REMARKS

ANNOTATED SHEET SHOWING CHANGES

FIG. 1  
PRIOR ART

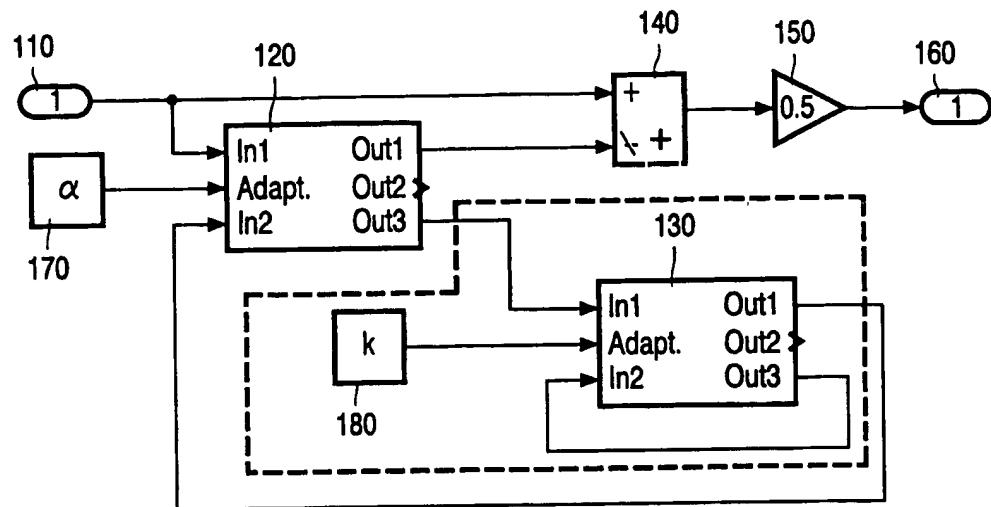
The Examiner has objected to the drawings indicating that the second inputs to the elements 320 and 370 should be a “-” sign as opposed to the shown “+” sign. Applicant believes that the Examiner is mistaken. In particular, in the Substitute Specification on page 15, paragraph [0040], the elements are referred to as first summing block 320 and second summing block 370. Further, on page 16, lines 1-3, the output of the first summing block 320 is described as “the addition of...”, while, at page 17, lines 8-11, the output of the second summing block 370 is described as “the sum of...”. Rather, as shown in the accompanying drawing change, in Fig. 1, the “-” input of element 140 should be a “+” sign (see Substitute Specification, page 4, lines 10-13).

Applicant proposes to revise the input symbols of the summer 140 in Fig. 1, and to insert the caption "PRIOR ART" into Figs. 1 and 2 of the drawings in accordance with the accompanying ANNOTATED SHEET SHOWING CHANGES. These changes are incorporated in the accompanying REPLACEMENT SHEET.
